THENCE N45°59'28"E A DISTANCE OF 314.01 FEET; THENCE N42°40'08"W A DISTANCE OF 258.35 FEET; THENCE N41°13'47"W A DISTANCE OF 258.35 FEET;	719-684-2298
THENCE N36°51'01"W A DISTANCE OF 37.27 FEET; THENCE N34°43'55"W A DISTANCE OF 165.41 FEET; THENCE N00°42'15"W A DISTANCE OF 128.76 FEET TO THE POINT OF BEGINNING	NORTH
SAID PARCEL CONTAINS A CALCULATED AREA OF 1,546,297 SOUARE FEET (35,498 ACRES; MORE OR LESS).	
BASIS OF BEARINGS: THE WEST LINE OF THE SOUTHWEST QUARTER OF THE NORTHEAST QUARTER (SW1/4 NE 1/4) SECTION 29, T125, R65W, 6TH P.M., EL PASO COUNTY, COLORADO, BEING MONUMENTED ON THE SOUTH BY A FOUND 3 1/4" ALUMINUM CAP STAMPED "PLS 4842" AND ON THE NORTH BY A 1 1/2" ALUMINUM CAP STAMPED "PLS 26965", AND IS ASSUMED TO BEAR N00°13'10"W, A DISTANCE OF 1,324.32 FEET.	& 5229 00 035 400
	S 5229 00 034 1"=200' 2 ^{20'}
SOILS & GEOLOGIC HAZARDS PLAN	
	PARCEL NO.S PLAN SCALE CONT. INT. = 2'
	ISSUED FOR: COUNTY REINSTATEMENT

PCD PROJECT NUMBER

SP205

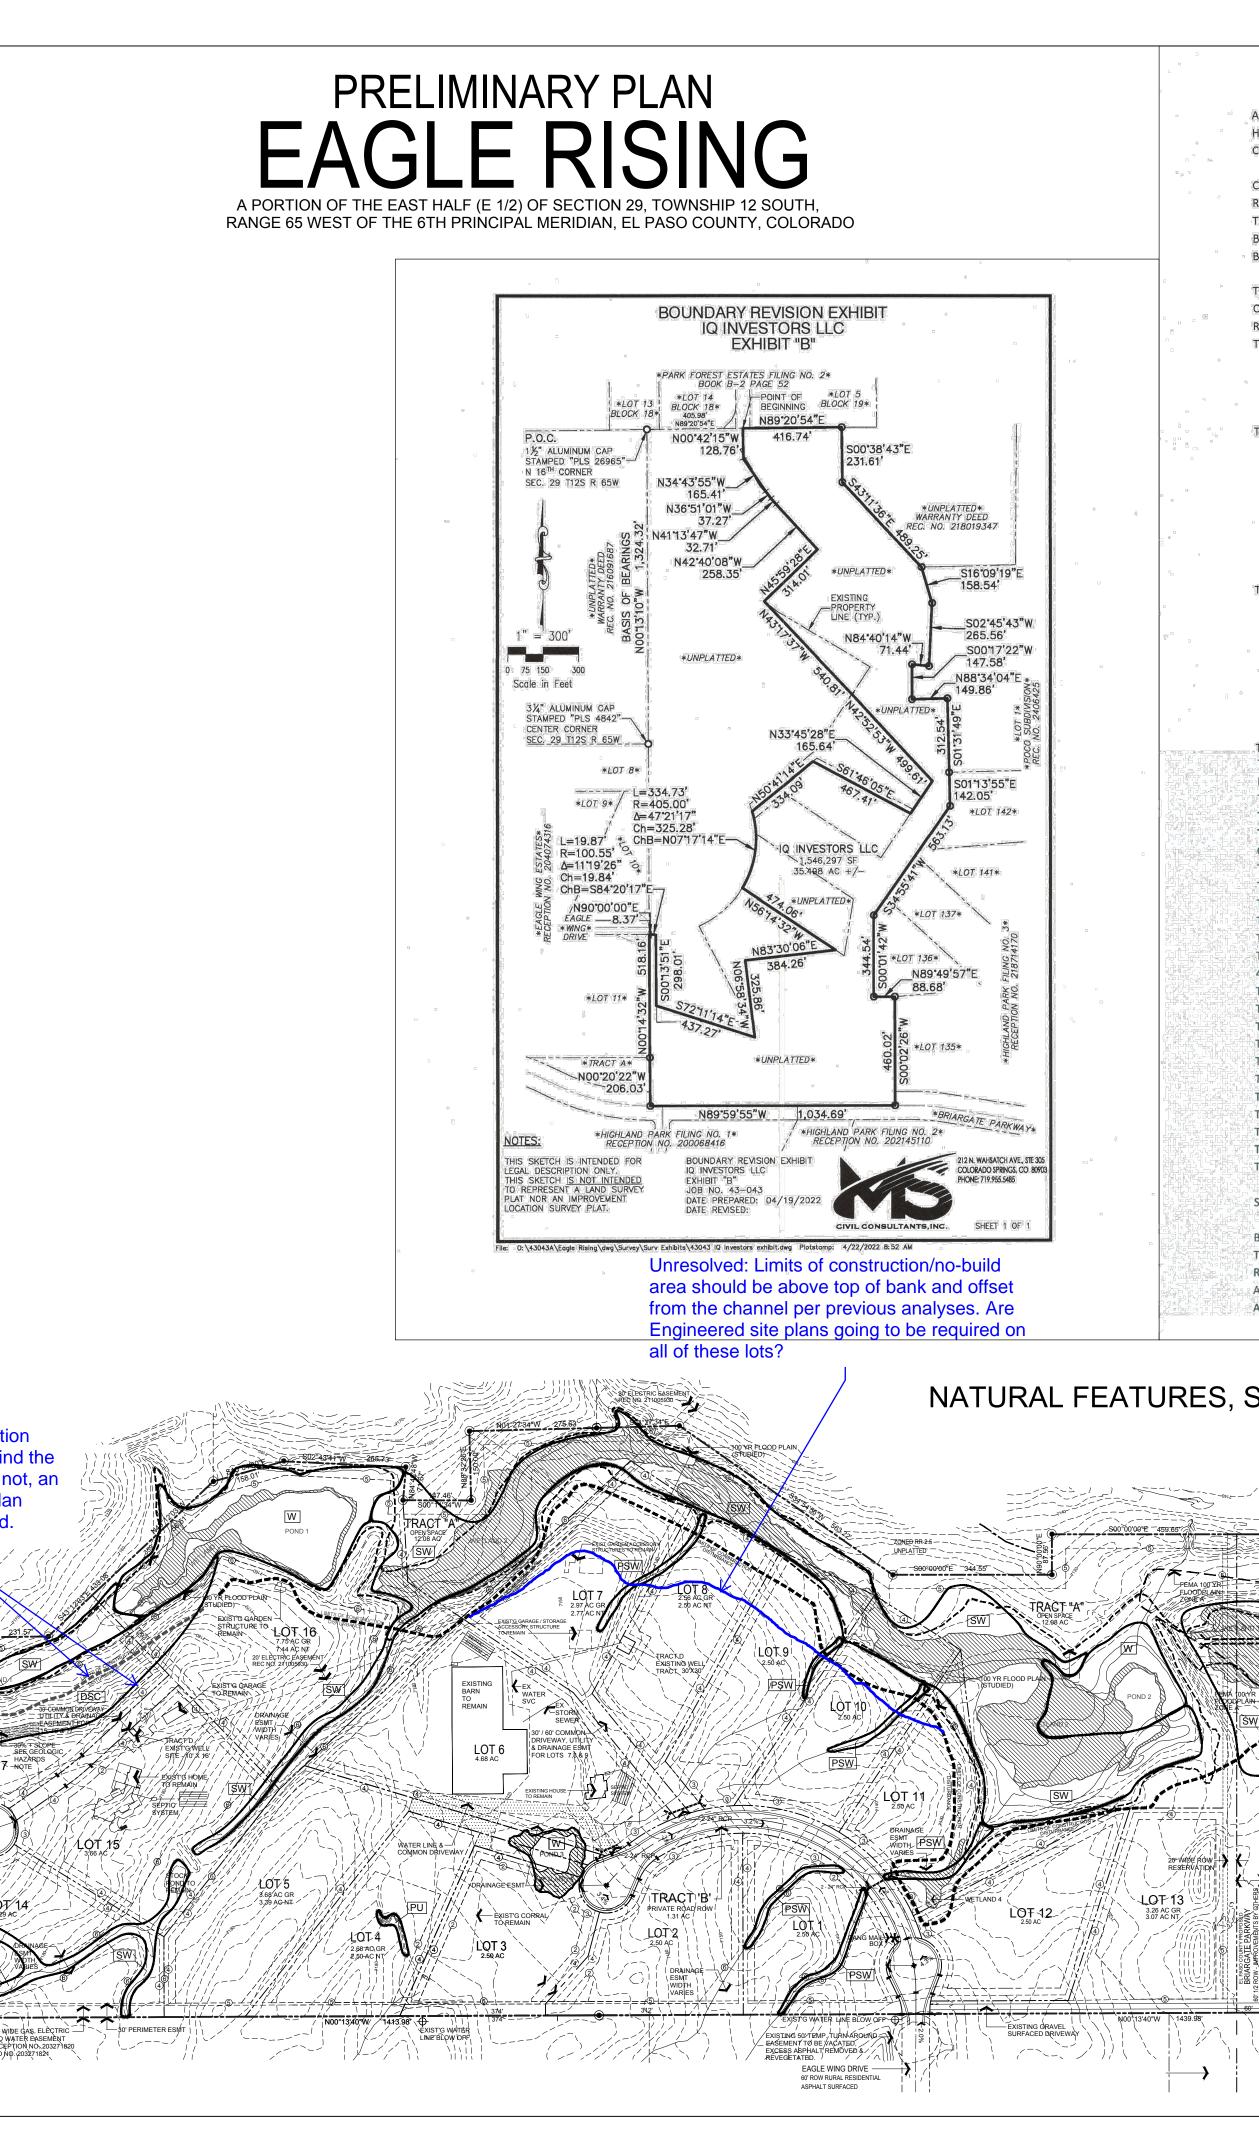
Limits of construction should follow behind the DSC line here? If not, an engineered site plan should be required.
